Response to Further Advice Request and Notice of Minor Changes in relation to Development Application at Toowong Central (Council Ref.: A006836692)

On behalf of *Toowong Central Investment Holding Pty Ltd (the Applicant)*, please find below and attached a full response to the request for Further Advice issued on 8 May 2026, pursuant to Section 35.1 of the *Development Assessment Rules (DA Rules)*, to assist with Brisbane City Council's (**Council**) assessment and decision of the development application at Toowong Central (Council Ref.: A006836692).

This correspondence also constitutes written notice, pursuant to Section 52(1) of the *Planning Act 2016 (Planning Act)*, of proposed changes to the development application, as identified in the amended plans and supporting technical material. The proposed changes are made either in direct response to matters raised in Council's Further Advice Request and the concerns raised by the submissions received during public notification, or otherwise constitute a minor change. In accordance with Section 26.1(c) of the DA Rules, the assessment process does not stop where the assessment manager is satisfied that any change that is not a minor c

Figure 2 – Roof Site Plan Comparison

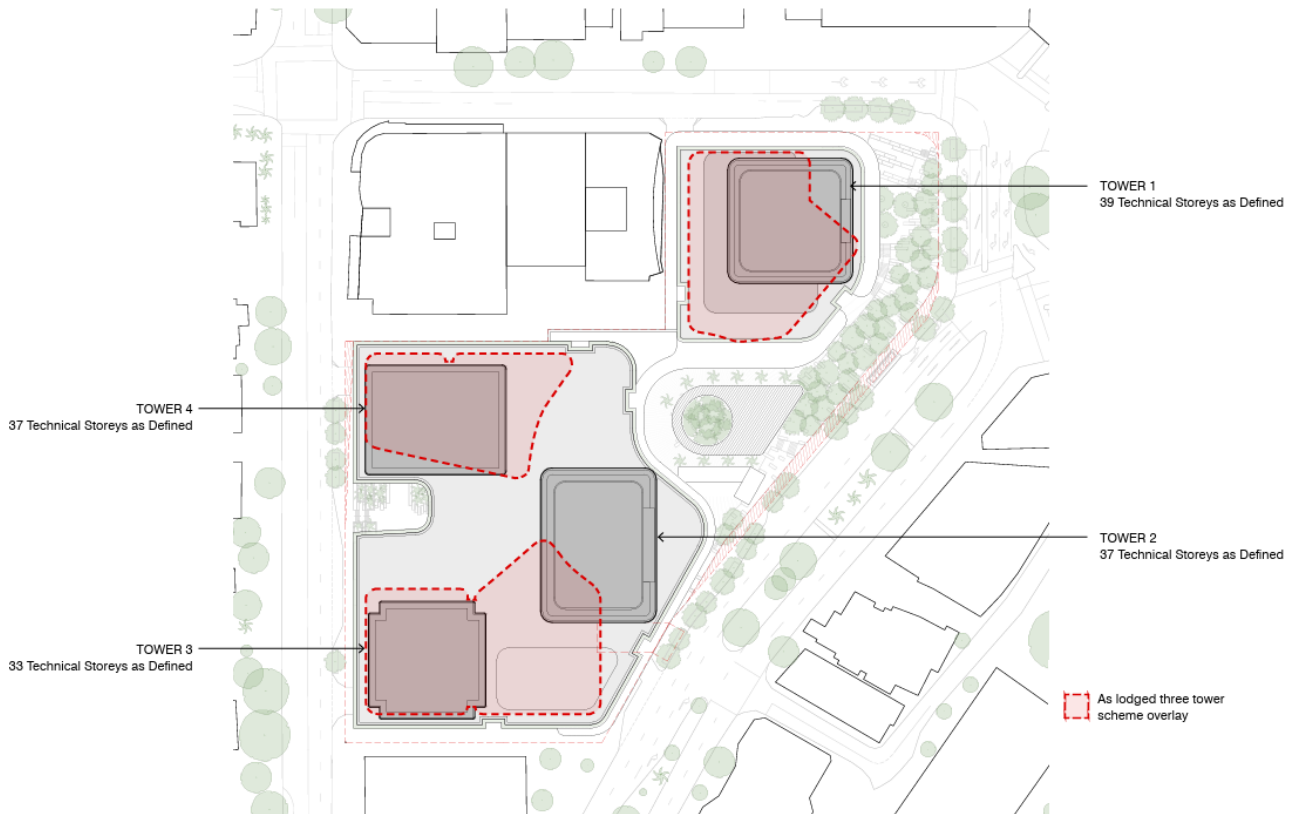
The building heights of the proposed towers are a departure from the heights anticipated for the site under the City Plan. Toowong centre does not form part of the inner city context and is therefore not intended to have similar densities, heights or built form as that found in inner city locations. The proposed heights are also expected to result in extended overshadowing.

- a. Provide a revised proposal with building heights that are aligned to the intent for the Toowong Centre and existing and approved development in the locality.

In response to **Item 1(a)** and feedback from the community and Council, the Applicant has reviewed the design and elected to reduce the overall building height. The revised scheme comprises a maximum of **39 technical storeys** (reduced from 58), representing an overall height reduction of **19 technical storeys**.

An opportunity has also been identified to redesign the rooftop level of each tower to provide additional communal open space in accordance with the rooftop garden design criteria under Schedule 1 of the *Brisbane City Plan 2014* (version 33) (**City Plan**)¹. Notably, rooftop garden does not constitute as a storey under the City Plan.

Figure 6 – Tower 1 Podium, Sherwood Road

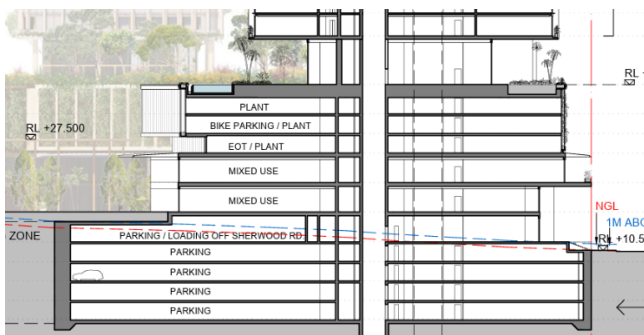
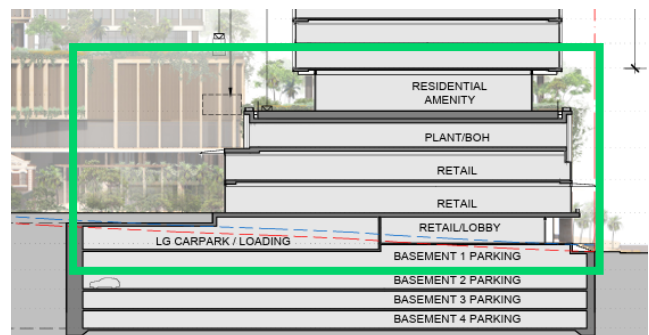
The proposed six storey podium height fronting Sherwood Road is in excess of the four storey height anticipated in AO1.5 of the Toowong—Auchenflower neighbourhood plan, and the podium height of approximately 26m above the street level appears imposing to the street and is not apparent that the podium height will result in a cohesive streetscape and contribute positively to the character and form of Sherwood Road.

- a. Amend the podium height relative to Sherwood Road to be more consistent with the intent of the neighbourhood plan.

In response to **Item 2**, the podium height of Tower 1 fronting Sherwood Road is proposed to be reduced from six (6) technical storeys to four (4) technical storeys, as illustrated in **Figure 6** below.

Significantly, the revised podium height at Tower 1 achieves compliance with Acceptable Outcome AO1.5 of the Toowong–Auchenflower neighbourhood plan, which prescribes a maximum podium height of four (4) storeys within the centre zone.

Figure 7 – Sherwood Road Activation (Tenancies)

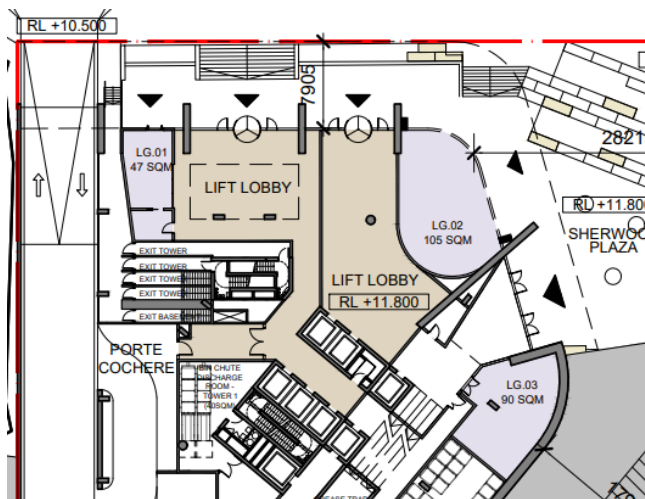
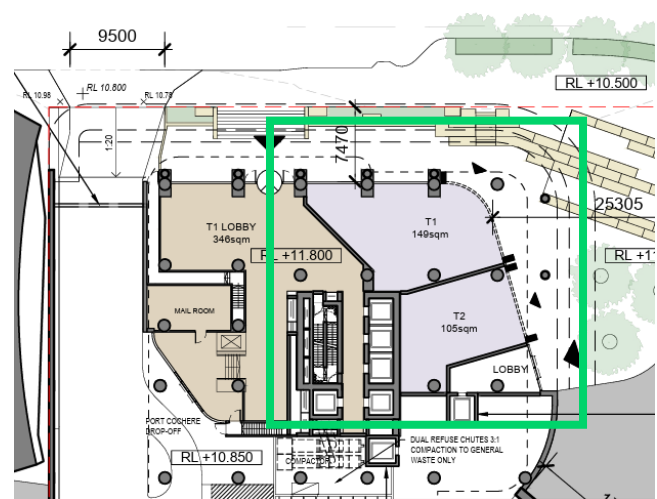
Sherwood Road ground level includes extensive lobby areas for hotel, office and residential access rather than achieving active and vibrant, small-scale retail and food and beverage offerings to the majority of the street frontage as identified in AO2.1, AO2.2 and PO2 of the Toowong–Auchenflower neighbourhood plan. PO10 of the Toowong–Auchenflower neighbourhood plan sets an expectation for the Sherwood Road frontage to be highly activated as a primary frontage.

- a. Amend the design of the ground level where proximate to Sherwood Road to provide a greater mix of highly activated uses (e.g. food and beverage or retail).

In response to **Item 3** of Council’s Further Advice Request, the Applicant has identified an opportunity to further improve activation and surveillance of Sherwood Road through minor reconfiguration of ground and podium levels in accordance with AO2.1, AO2.2, PO2 and PO10 of the Toowong-Auchenflower neighbourhood plan code.

As shown in **Figure 7**, the revised layout consolidates the retail tenancies within a single area directly addressing Sherwood Road and the north-eastern corner of the site facing Toowong Village. The revised arrangement increases the size of these ground level tenancies to a total GFA of 254m², with additional activation opportunities facilitated through outdoor dining areas extending into Sherwood Plaza.

Figure 10 – Level 1 Site Plan Comparison

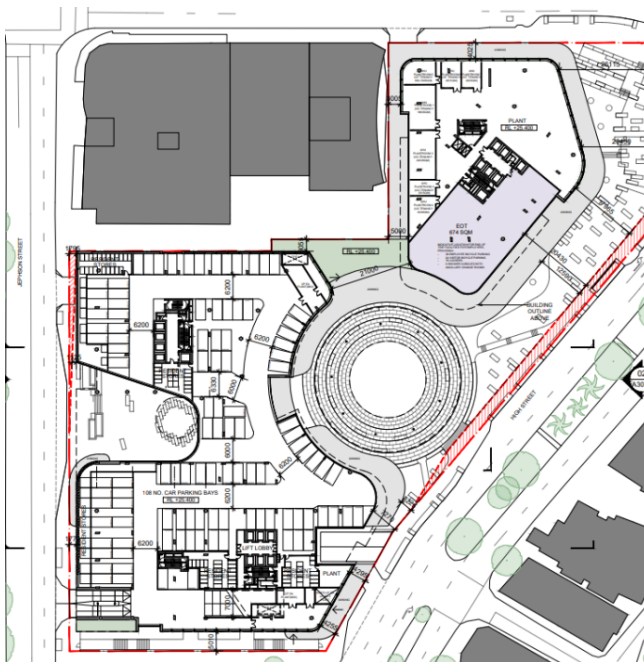
- a. Amend the design to ensure all street frontages have sufficient activation to levels above the ground level (level closest to the adjacent street).
- b. Provide façade design details (1:20/1:50) for all façade elements. This will include part plans, part elevations, part sections and part 3D images with sufficient annotation and dimensions to describe the intended outcome.

In response to **Item 4**, the Applicant has reconfigured the proposed podium Level 1 to incorporate additional GFA for indoor recreational space uses as illustrated in **Figure 10** below.

Figure 11 – Revised Tower Setbacks

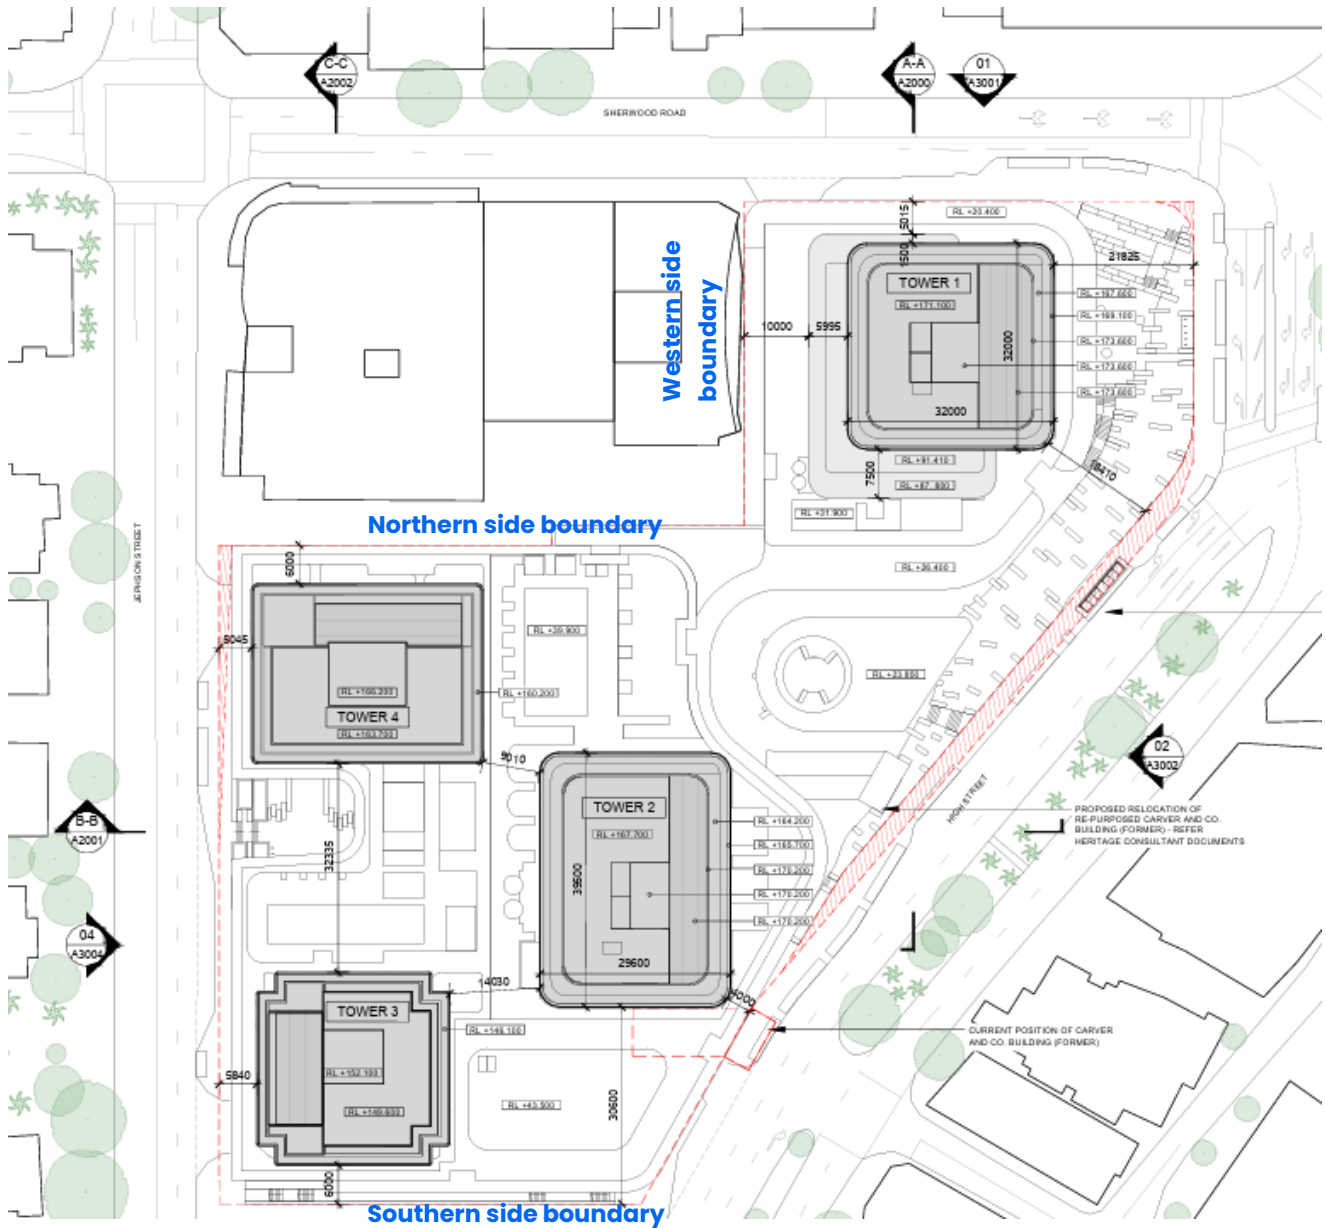
- a. Amend the tower setbacks to ensure future development is not prejudiced through the lack of adequate building separation.*
- b. Increase the side boundary setback to tower 3, which is currently shown 3.6m from the side boundary and considerably less than prescribed under AO1.2/PO1 of the Toowong-Auchenflower neighbourhood plan.*

In response to **Item 5** and the broader concerns outlined in Council's Further Advice Request, the Applicant and its project team have revised the overall design of the proposal to introduce a fourth tower, resulting in consequential adjustments to boundary setbacks.

The introduction of the fourth tower and revised setbacks resolves the potential of the development to prejudice redevelopment of its adjoining neighbours as raised in this Item.

As demonstrated in **Table 1** and **Figure 11**, the amended setbacks improve on the as-lodged scheme, particularly along the northern and western side interfaces. The revised minimum setbacks to sensitive interfaces are generally no less than 6 metres, providing sufficient separation to avoid adverse amenity impacts.
